## Authors' response to reviewer comments

### **Reviewer #1**

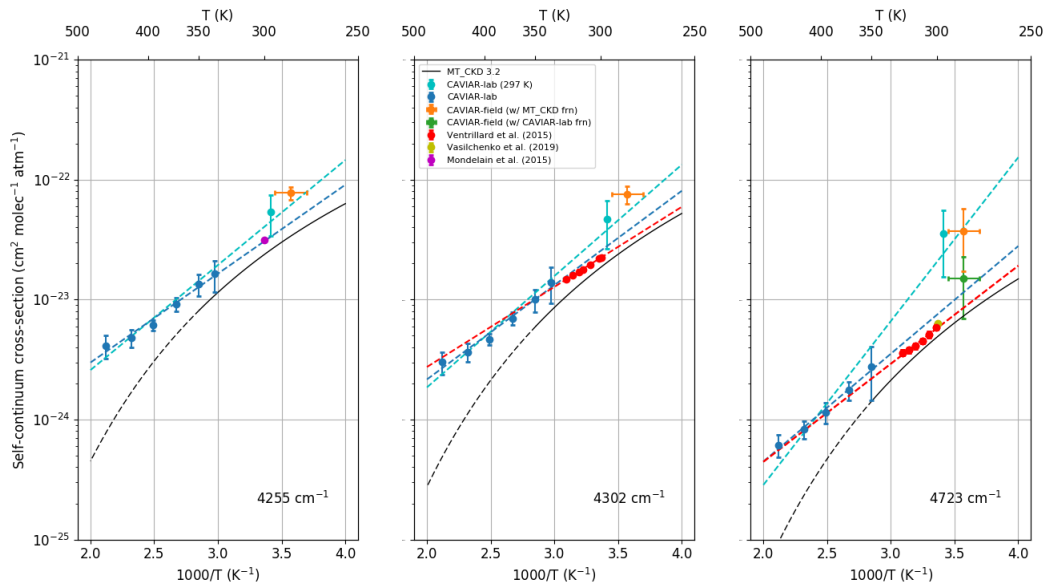
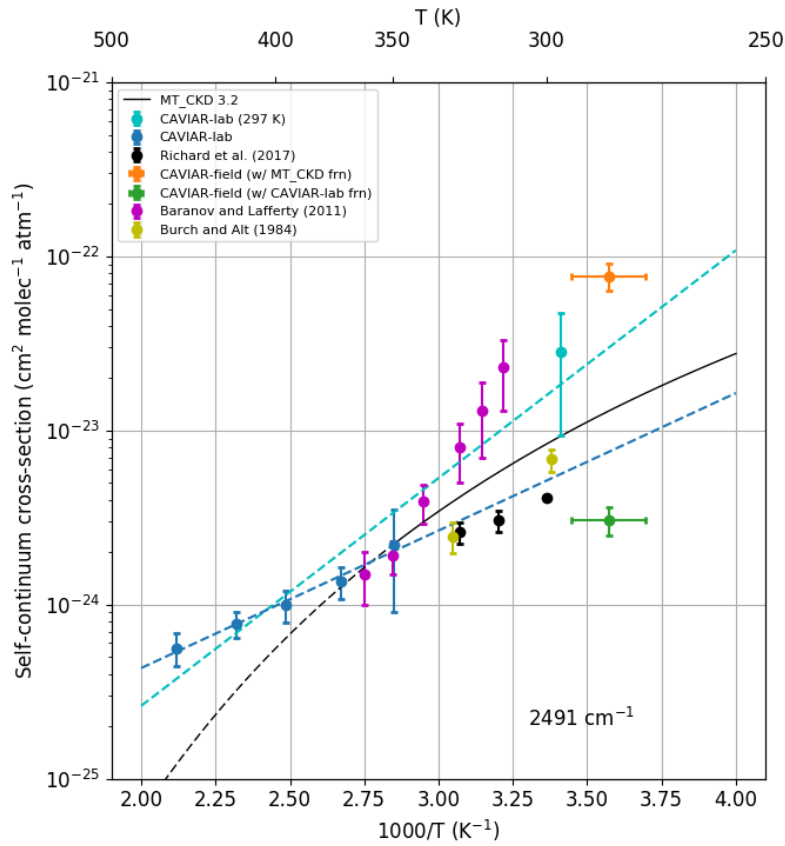
.P24, line 10: The authors refer to lower temperature data (cyan point and dashed line), but in figure 13 there is no cyan point and no cyan dashed line. Seemingly, this passage is from an earlier version of this paper. CAVIAR-lab (297K) should be removed from the legend in figure 13.

P26, fig. 14: CAVIAR-lab (297) is not anymore included in the figure, so it should be removed from the legend. The same applies to the caption.

*The versions of Figures 13 and 14 used in the uploaded drafts of the paper do not include this data point and the corresponding extrapolation – this was in error. The correct versions of these Figures are shown below – they are the figures uploaded for the original draft, but including the 297 K data in the legend. These are now included in the manuscript.*
